**Howard County
Health Department**

ONSITE SEWAGE DISPOSAL SYSTEM

PROPERTY ADDRESS: 1238 Morgan Station Rd

Septic Tank Replacement Plan

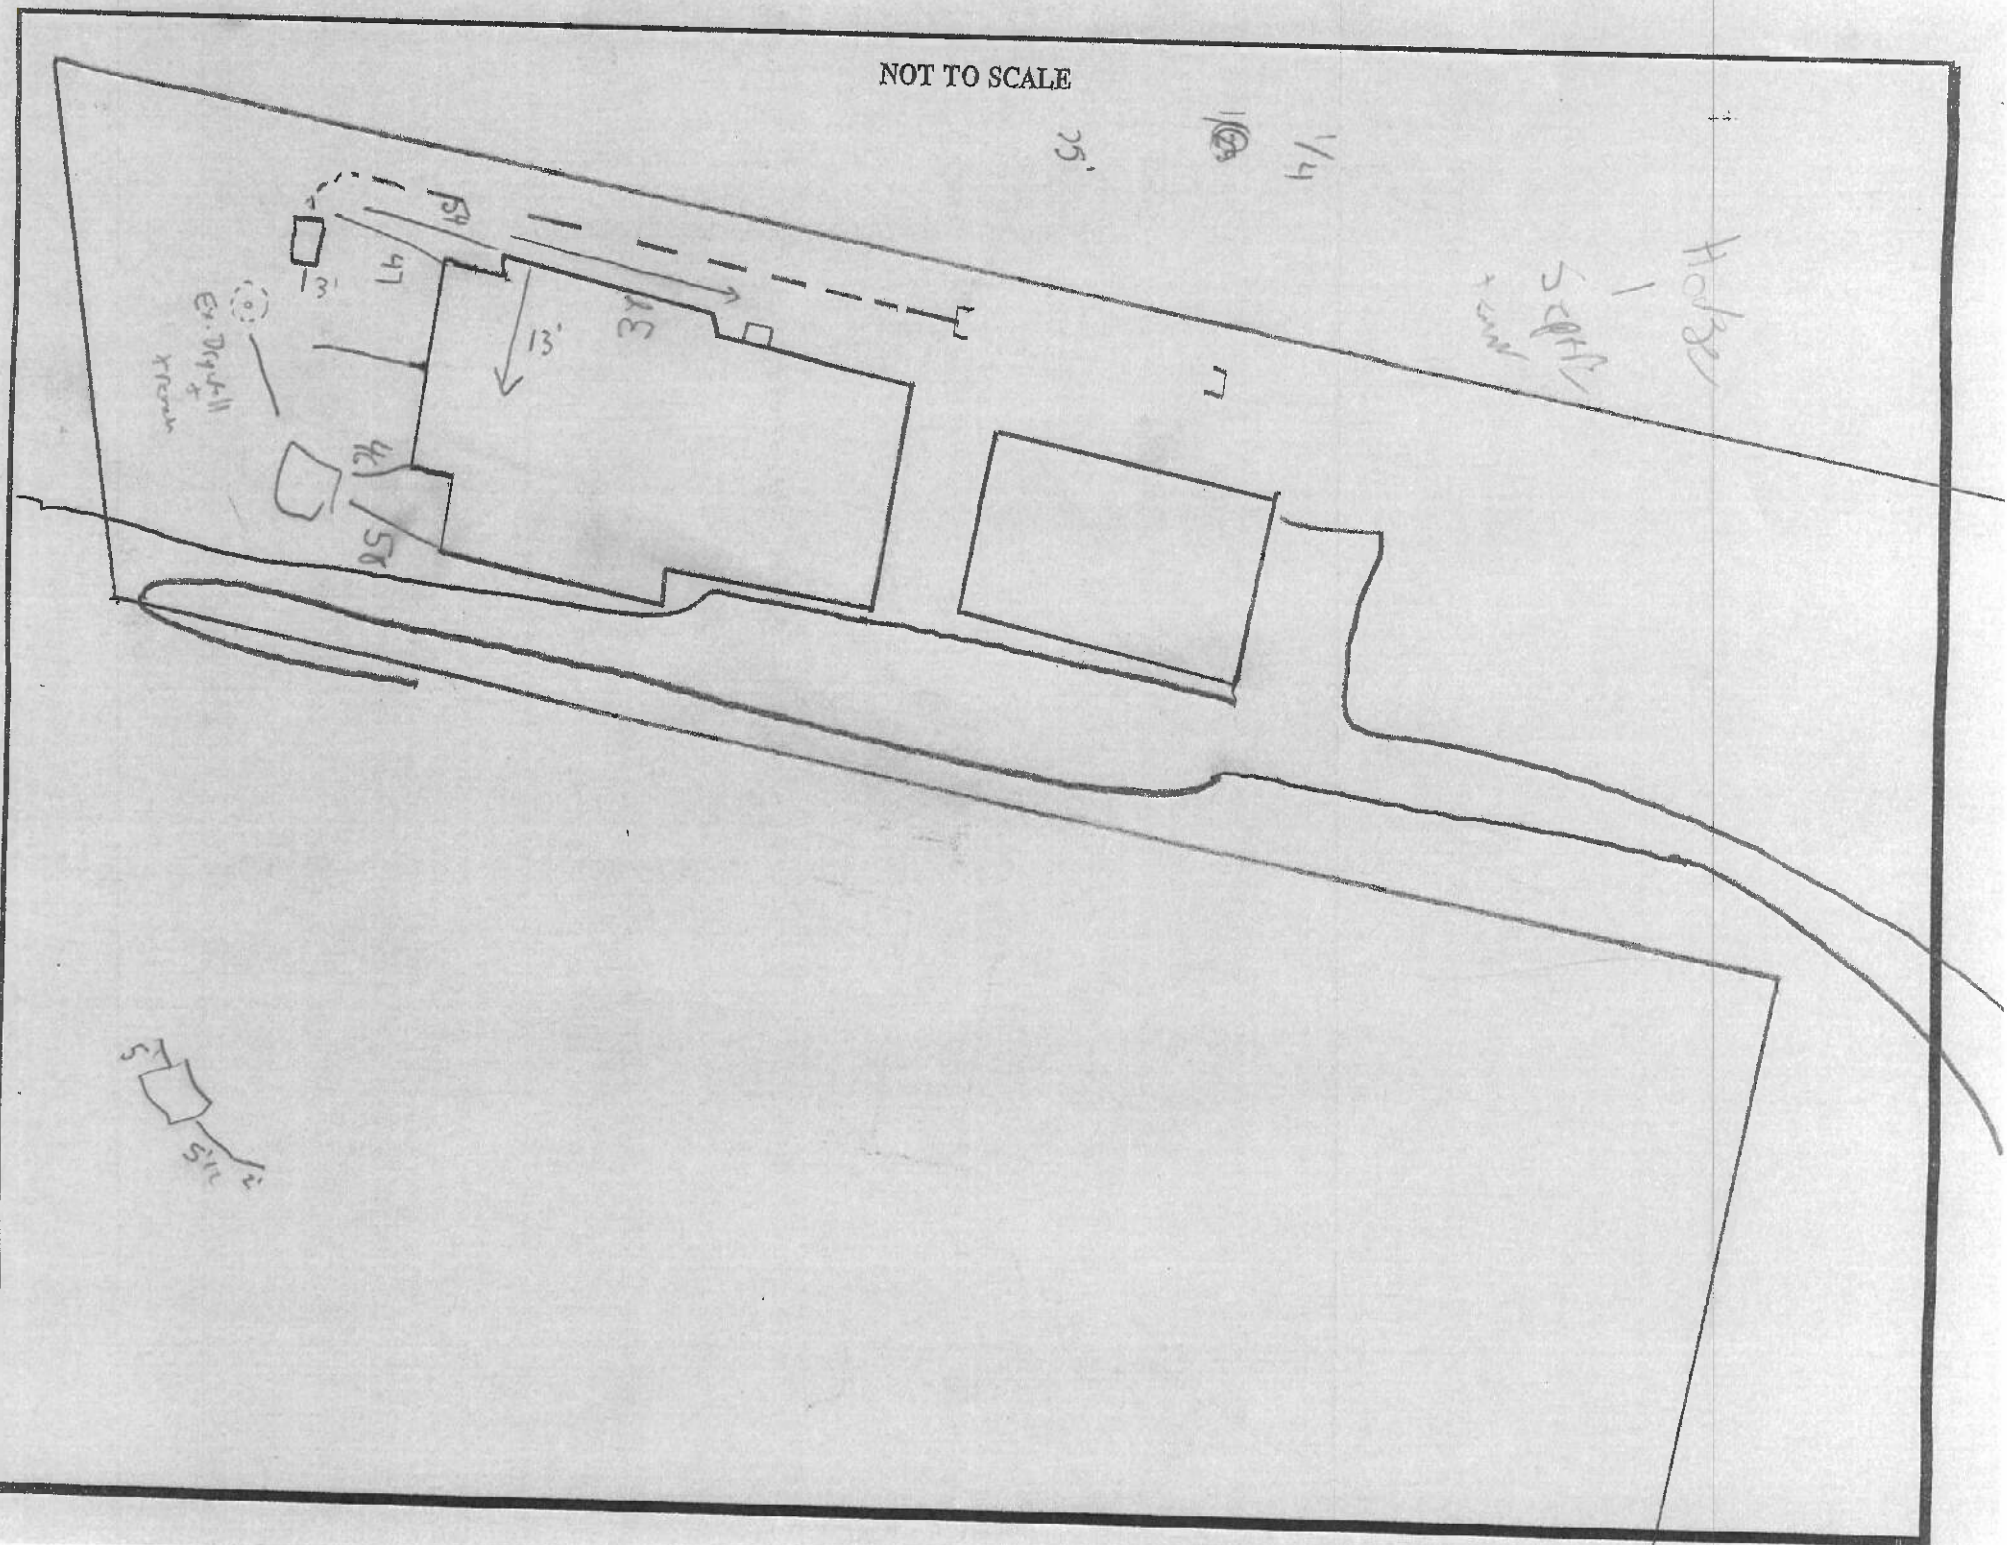
2/9/26 to work, Contractor needs to place mastic and riser is straight

2/10/2026 contractor installed green tank lid risers, replaces the corrugated risers. Contractor located trench, located behind the garage, starting underneath the concrete slab. Terracotta pipe contractor to confirm with homeowner that it is OK to saw through concrete to place d-box. Will confirm pipe condition later today and install an observation pipe in trench (MS)

2/11/2026 site inspection: Trench to be truck confirmed.

New d-box set near corner of garage. Add obs. pipe to trench. Add to verify 45° bend in d-box for flow. Verify pump & alarm (MS)

2/18/2026 - Electrical onsite for inspection. Rheonius installed on panel 36" above grade. Roof for alarm panel & successfully starts audible & visual alarm. Not enough water per pump to warn, reinspect for pump test.

Re-inspection, d-box exposed, no 90° turnaround @ ex d-box, electrical inserted turn down unit onsite. Pump successfully sends water to d-box.

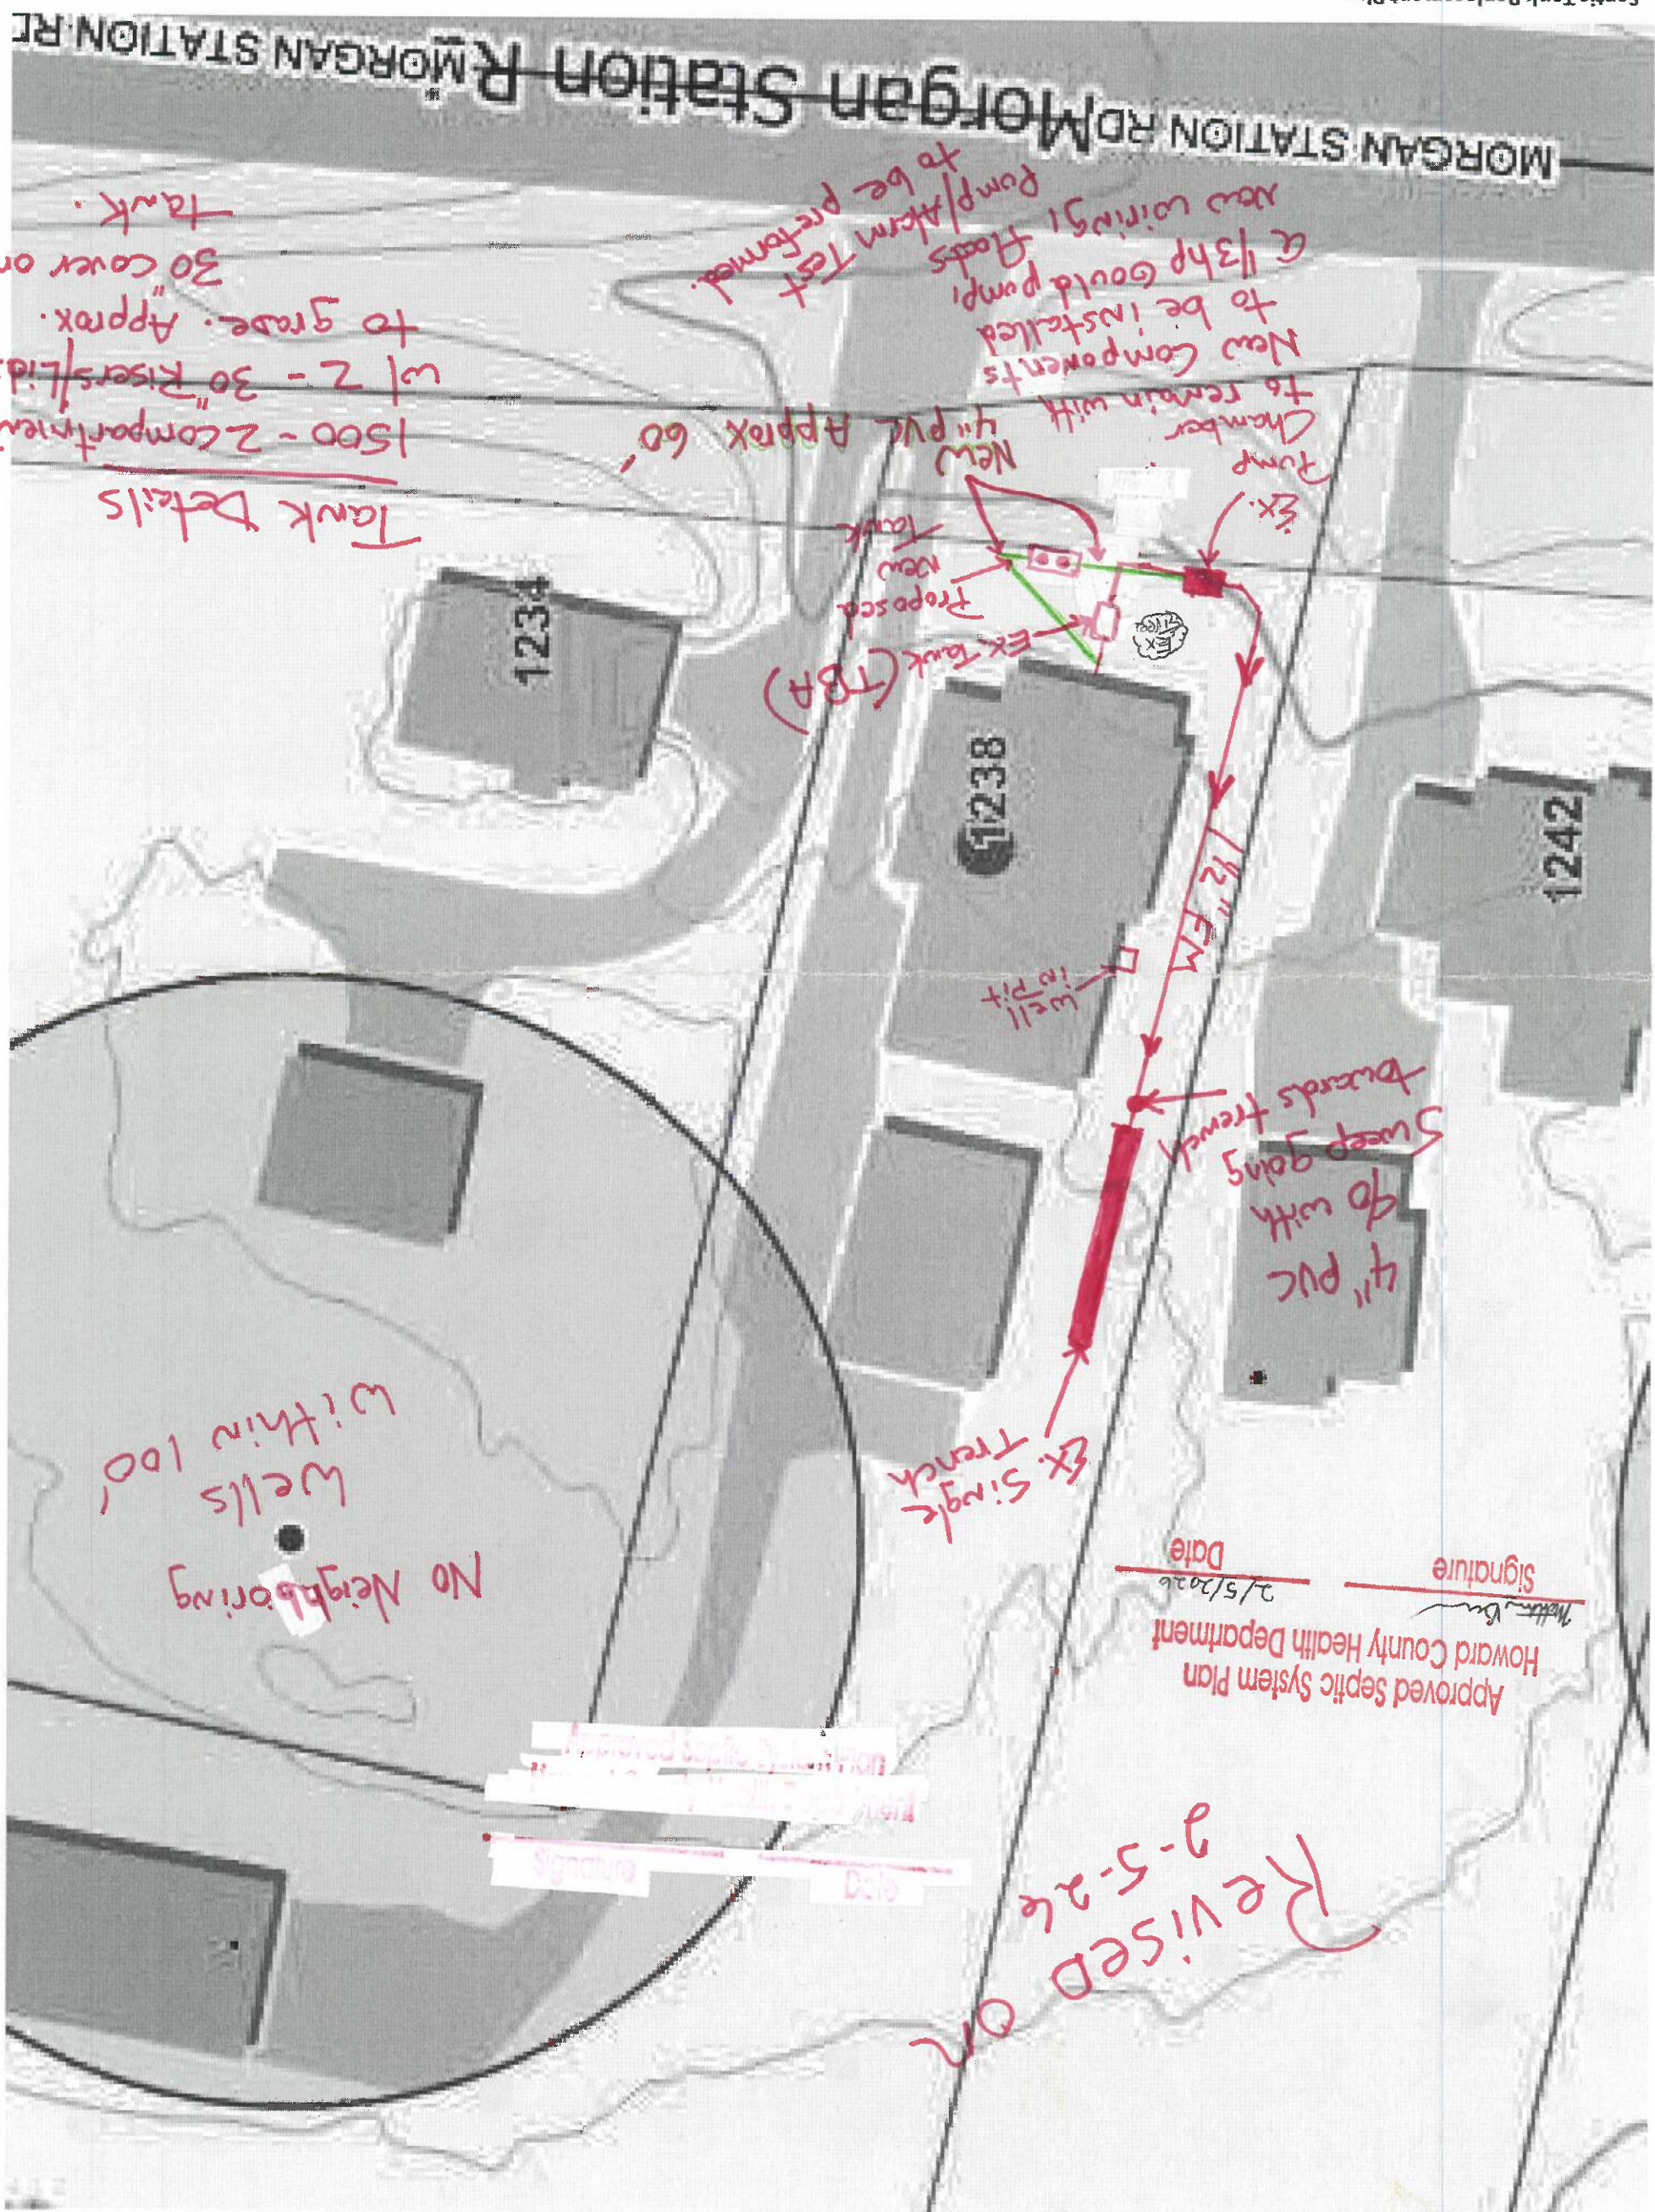
The revised plan you submitted says that it's a Tank Replacement.

Is Fogle's replacing both the septic tank and pump chamber? Or just one of the tanks?

How did Kurt determine the tank(s) were failing?

1. Label trench as "Existing trench"
2. Please note on the plan where and how much of the outlet line you are replacing
3. Note/label that you are replacing the risers
4. Label tanks as "Existing Septic Tank" and "Existing Pump Chamber"
5. If you are replacing the pump, a pump and alarm test will be required. To verify that the pump is operating at the trench, do you want to:
 - a. Install a d-box? And/or
 - b. Install an observation port at the end of trench?

1. Label trench as "Existing trench"
2. Please note on the plan where and how much of the outlet line you are replacing
3. Note/label that you are replacing the risers
4. Label tanks as "Existing Septic Tank" and "Existing Pump Chamber"
5. If you are replacing the pump, a pump and alarm test will be required. To verify that the pump is operating at the trench, do you want to:
 - a. Install a d-box? And/or
 - b. Install an observation port at the end of trench?

- Why tank needs to be replaced - *See Kurts evaluation*
- How was the trench verified to be functional - *Kurt probed the trench beginning to end*
- Tank depth of proposed tank (need to note this on revised drawing too) *30"*
- Along with the other repairs already noted

1. Label trench as "Existing trench"
2. Please note on the plan where and how much of the outlet line you are replacing
3. Note/label that you are replacing the risers *New Tank will have (2) NEW Riser S*
4. Label tanks as "Existing Septic Tank" and "Existing Pump Chamber"
5. If you are replacing the pump, a pump and alarm test will be required. To verify that the pump is operating at the trench, do you want to:
 - a. Install a d-box? And/or *NO*
 - b. Install an observation port at the end of trench? *NO*

c. We will install a 4" in-line s/o before the trench to observe that the pump is functioning.

Kurt says we are replacing tank because it has a hole in the side of it. Pump chamber itself is fine...just replacing components. I will be down late morning to revise drawing. Can you leave the plan up front? I should be there around 11:30. Thanks
